**NEW ELEMENTARY SCHOOL**  
9801 HIGHLAND KNOLLS DR  
BAKERSFIELD  
CALIFORNIA  
93308

**NEW MIDDLE SCHOOL**  
4115 VINELAND ROAD  
BAKERSFIELD  
CALIFORNIA  
93306

COPYRIGHT  
ORDIZ-MELBY ARCHITECTS, INC. 2010  
SHEET TITLE  
**ELECTRICAL PLAN  
BUILDING M**

**E-121M**  
SHEET OF

ELECTRICAL PLAN BUILDING M

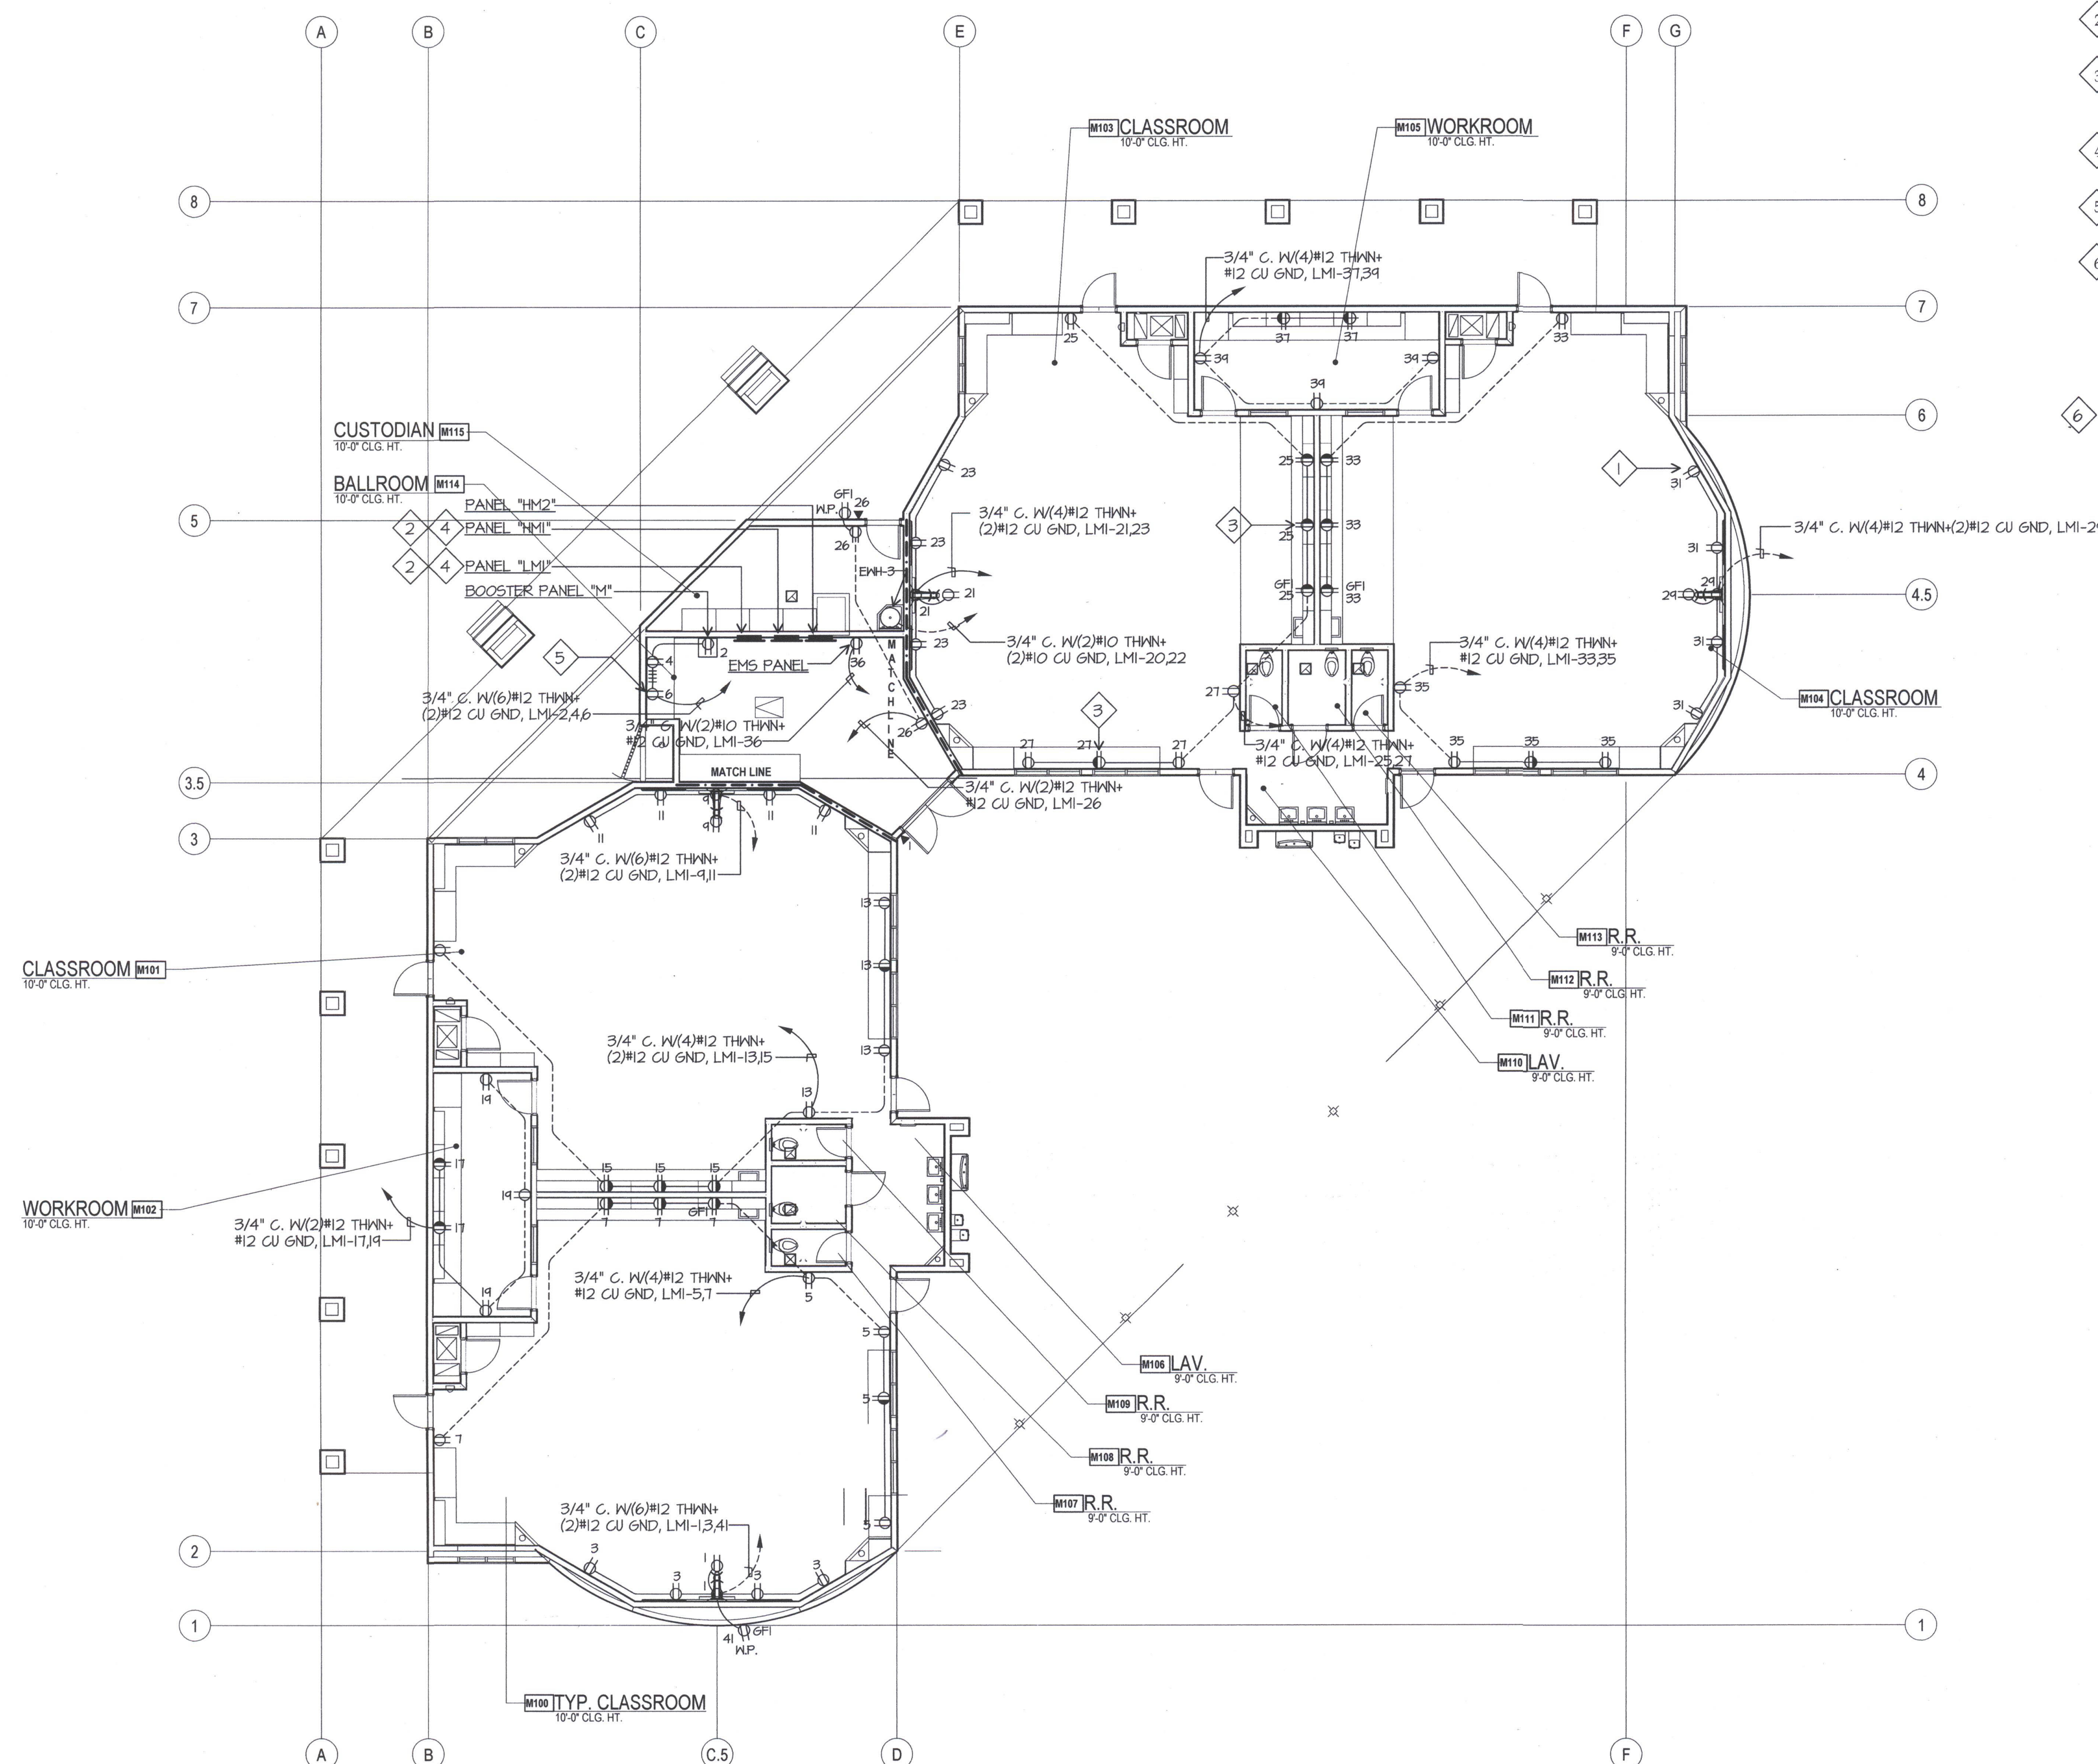
Request:  
RDM Electric - 2/8/13  
Reference Sheets E121M, E121N & E121P  
On the Electrical Plans for Building M, N & P, plan note #1 calls out for tamperproof receptacles to be installed in the classrooms. Please clarify if tamperproof receptacles are required in the workrooms and/or changing rooms, or just in the individual classrooms.

Answer:  
John Maloney - JMPE - 2/8/13  
They are not required in workrooms, changing rooms or private offices.
